Hillingdon

Outline Fire Strategy – Rev E

OF-OFS-3671-01-E

Appendix A – Drawing Comments

1 Building 6 - Ground Floor Plan

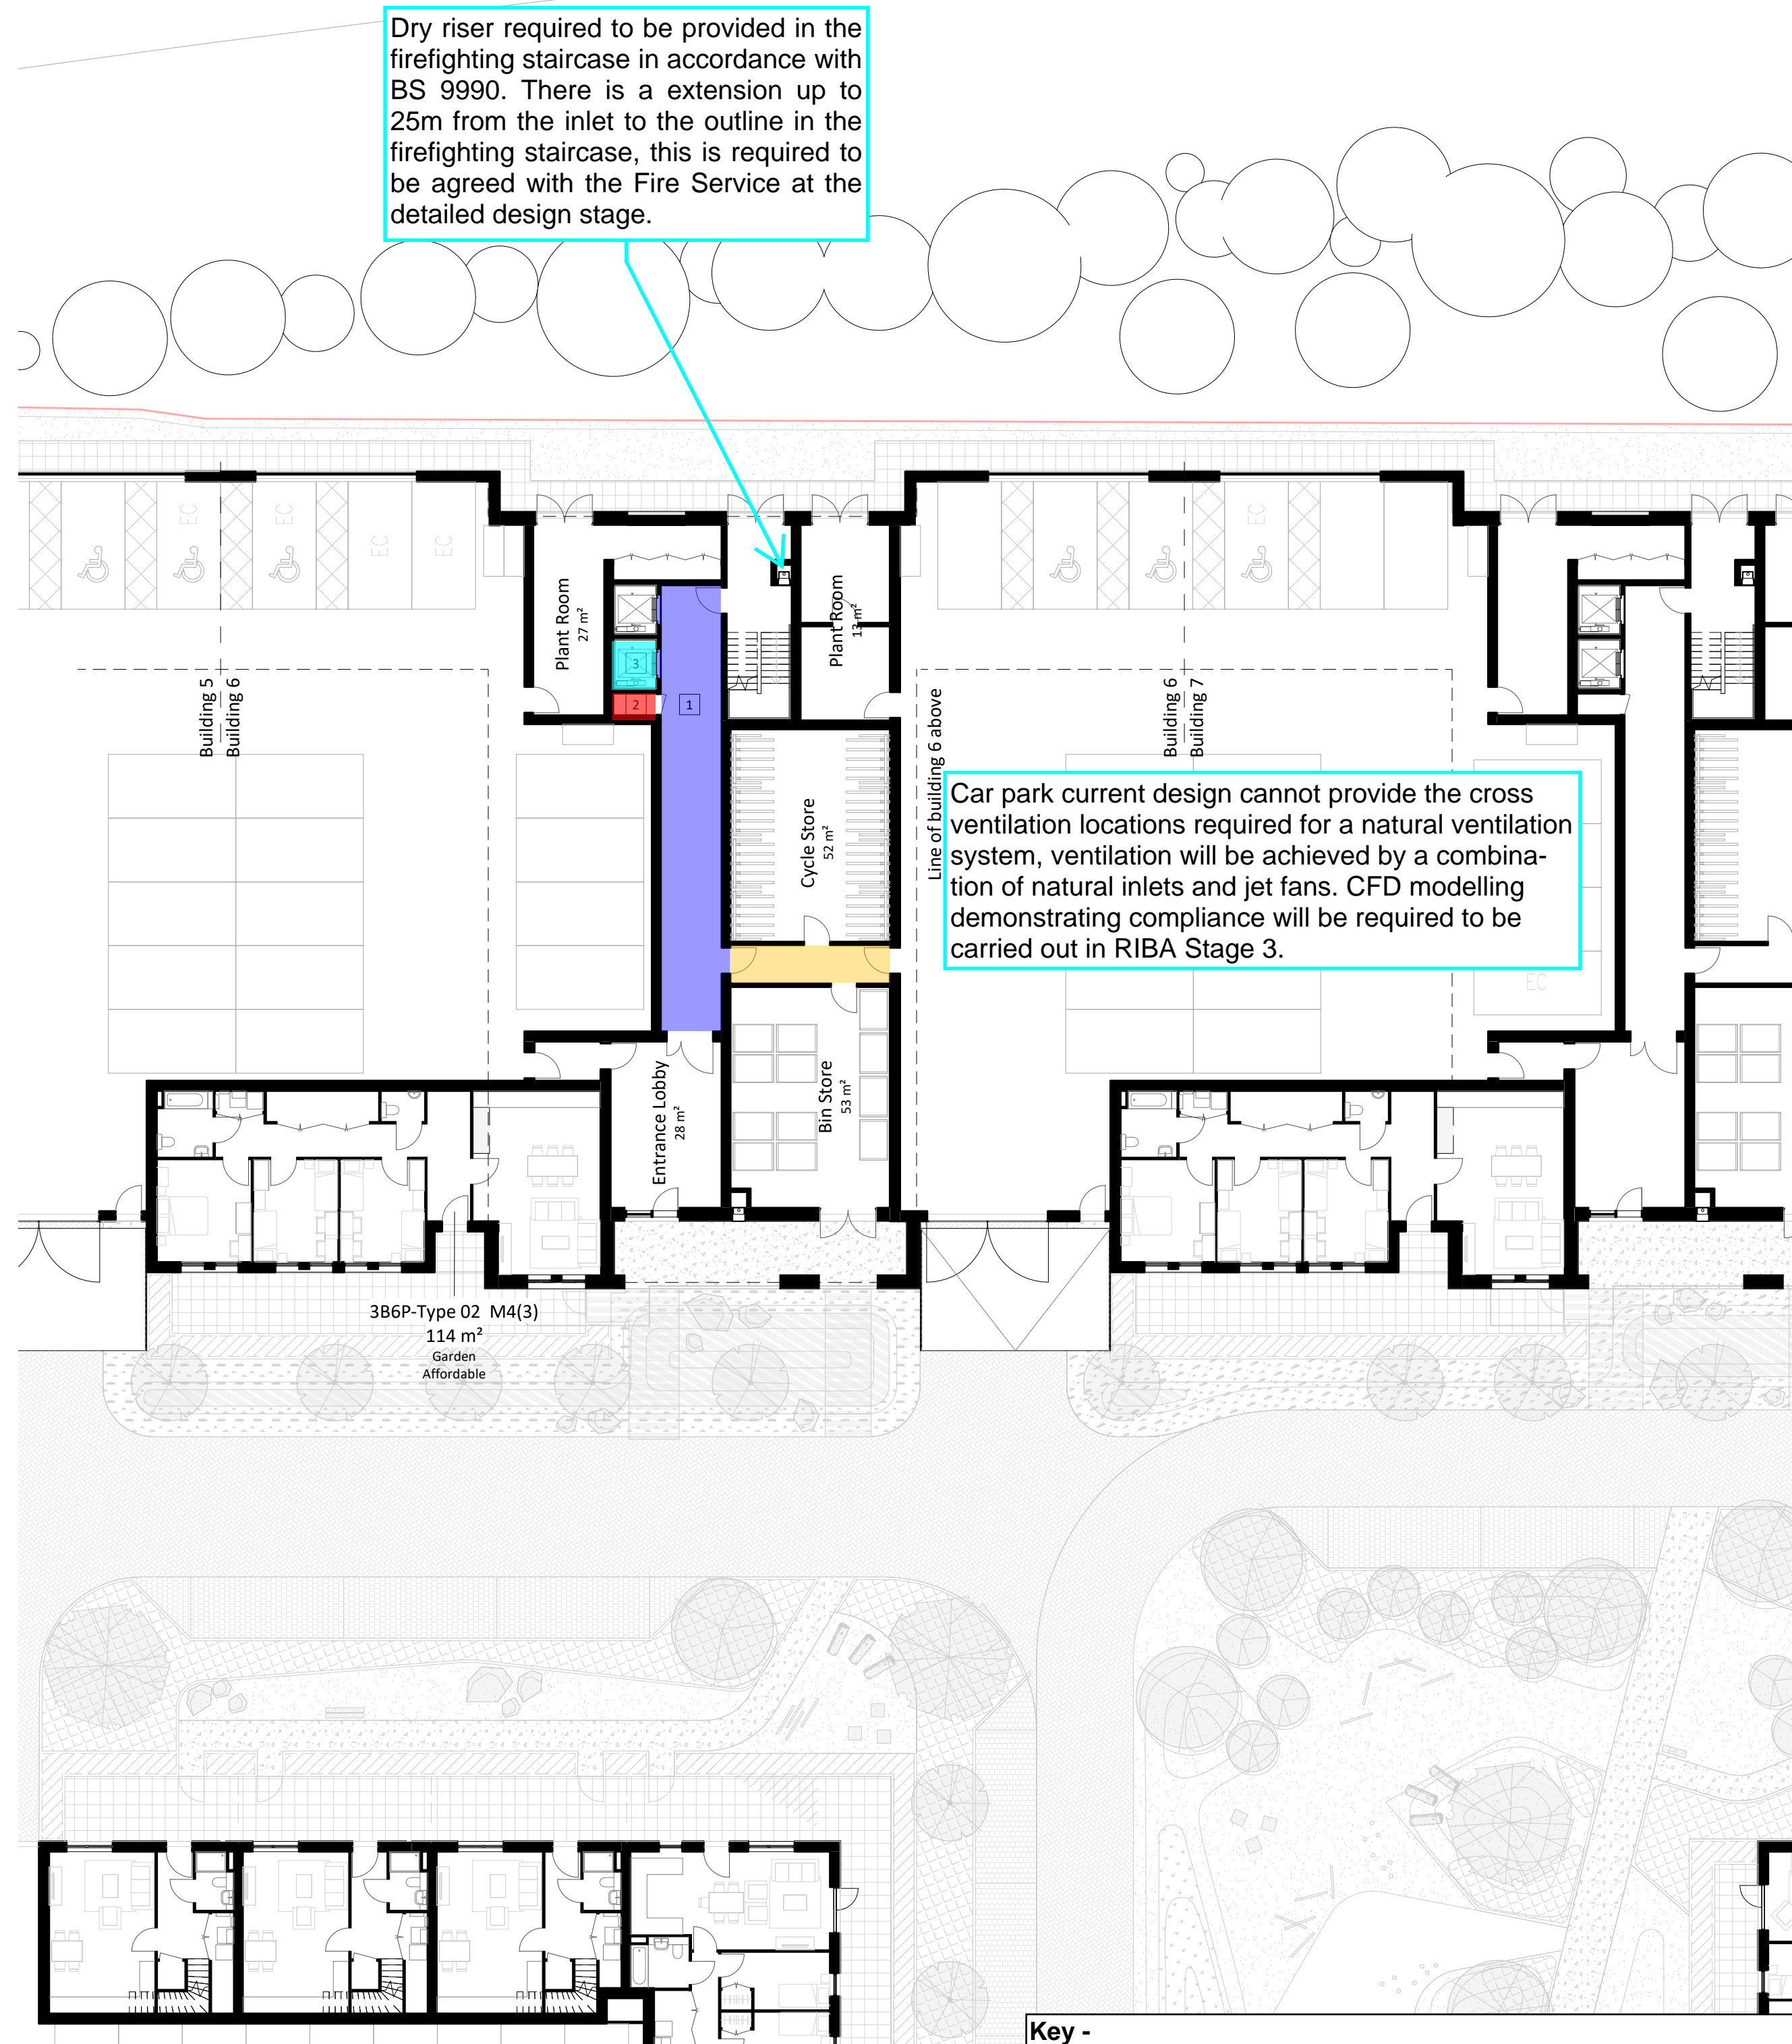
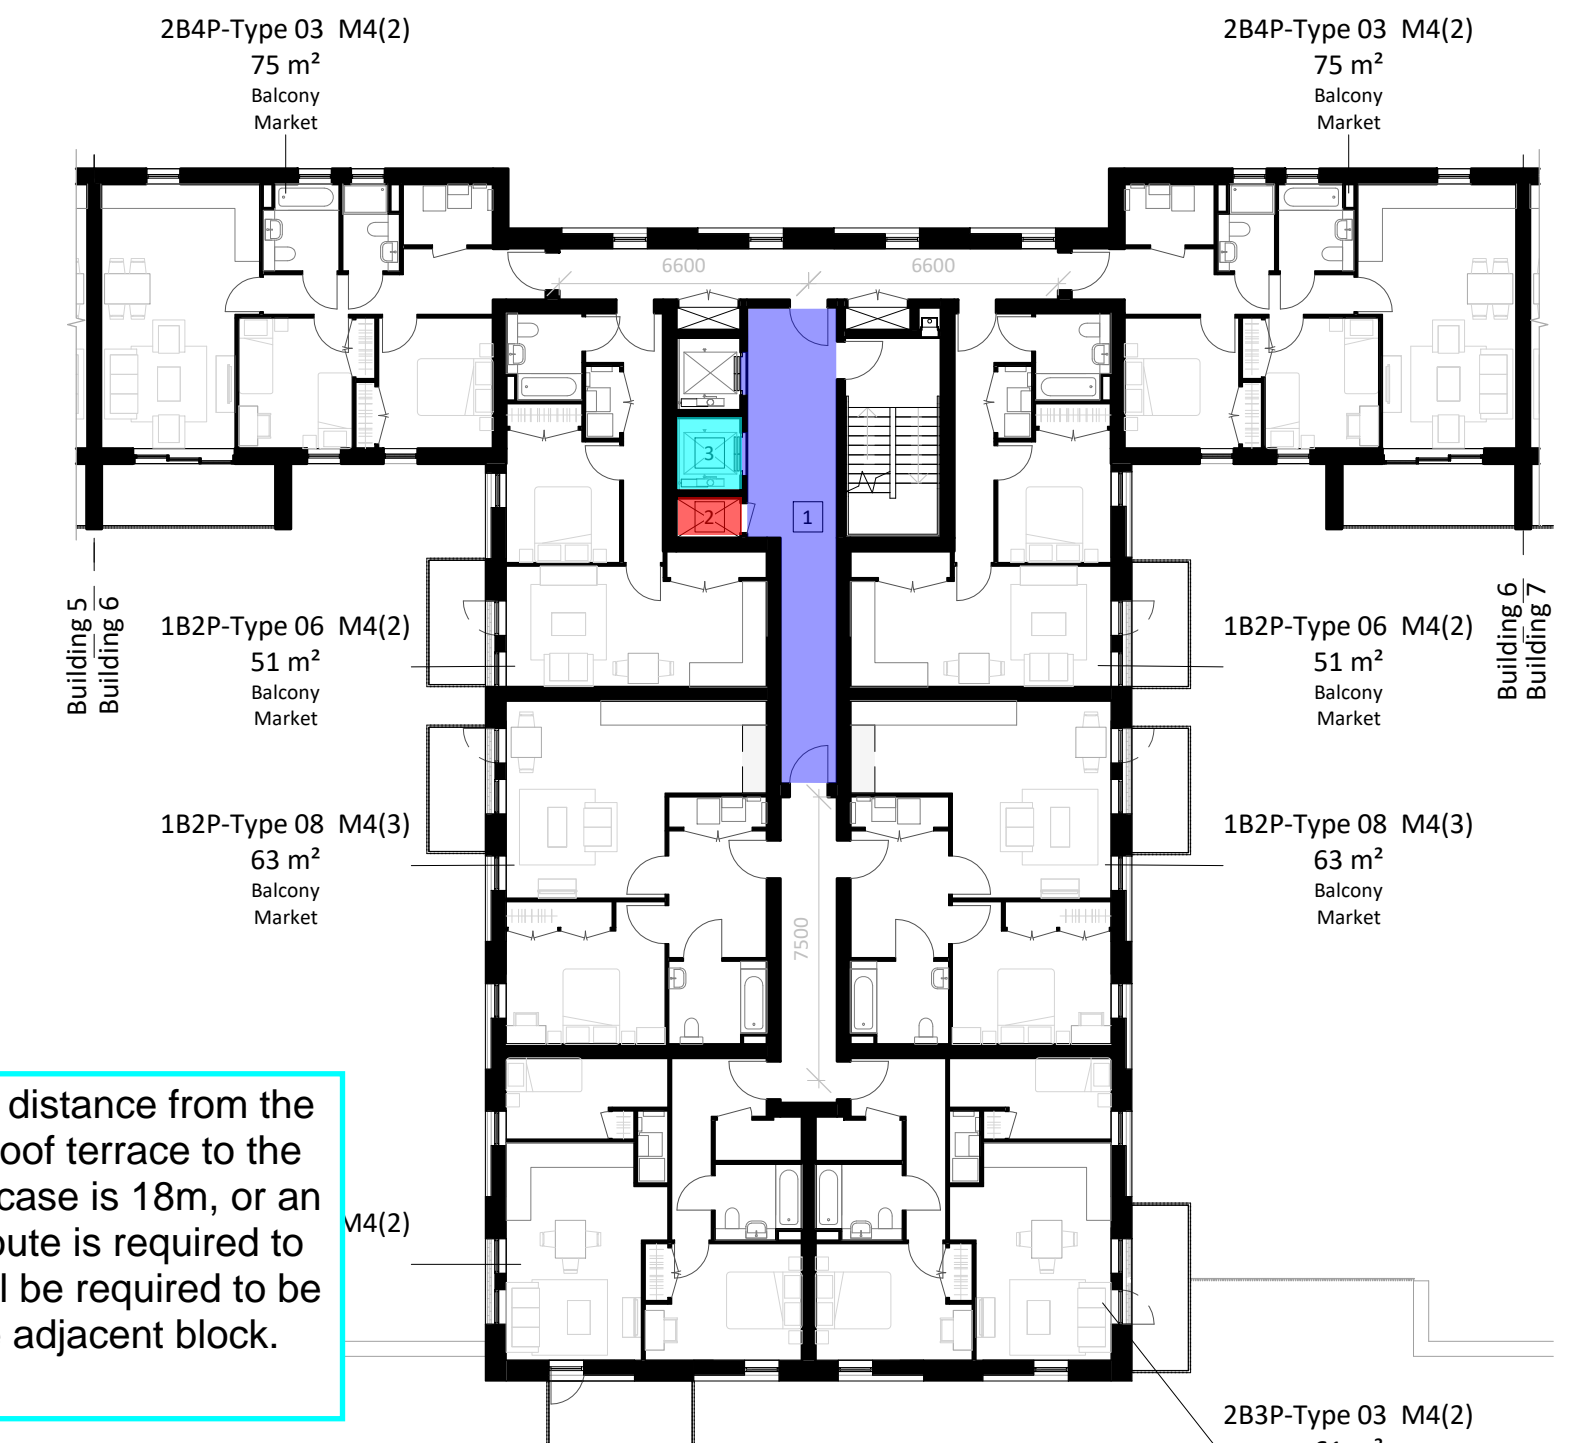
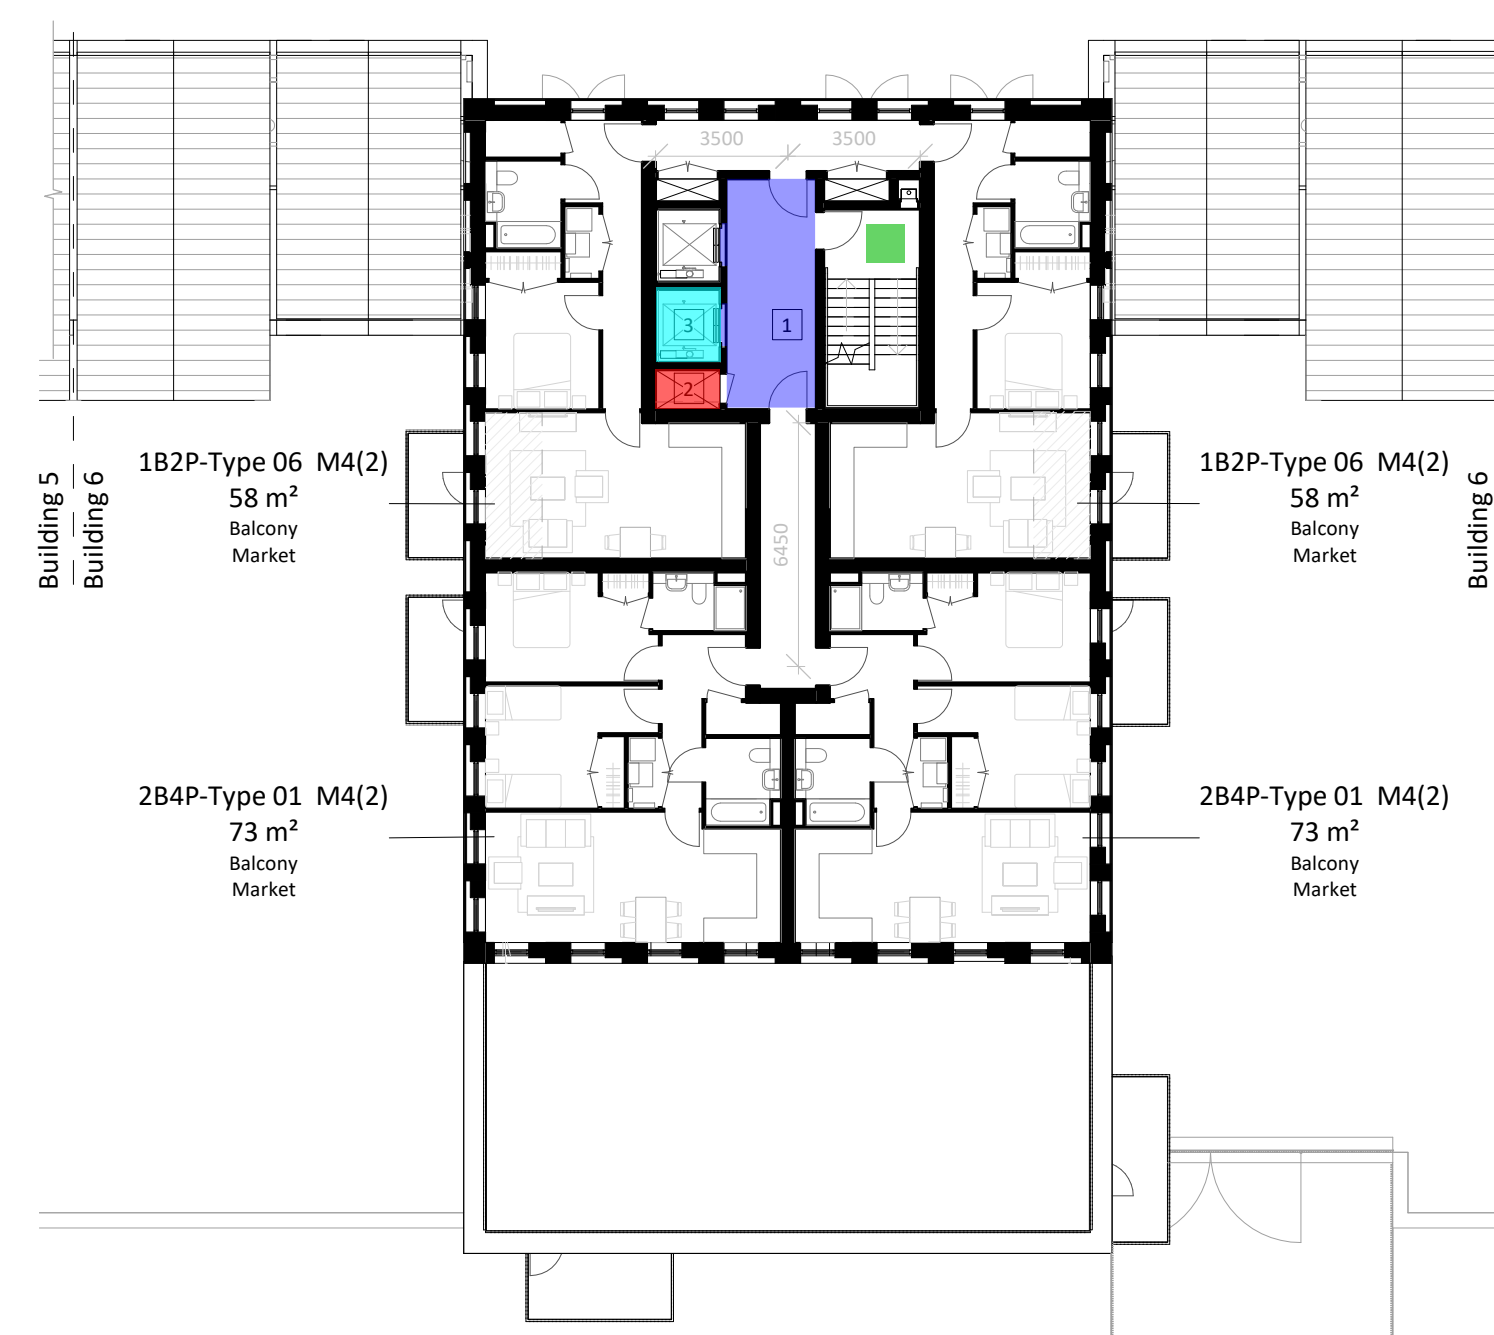
To be noted, if the service riser is to only contain water services or metal ventilation ductwork from the ground floor, it is considered a limited fire hazard. As such, this riser shaft may be located in the staircase lobby.

To be noted, the government have stated from May 2020, all new building's over 11m in height are required to be provided with sprinklers, see Section 9.
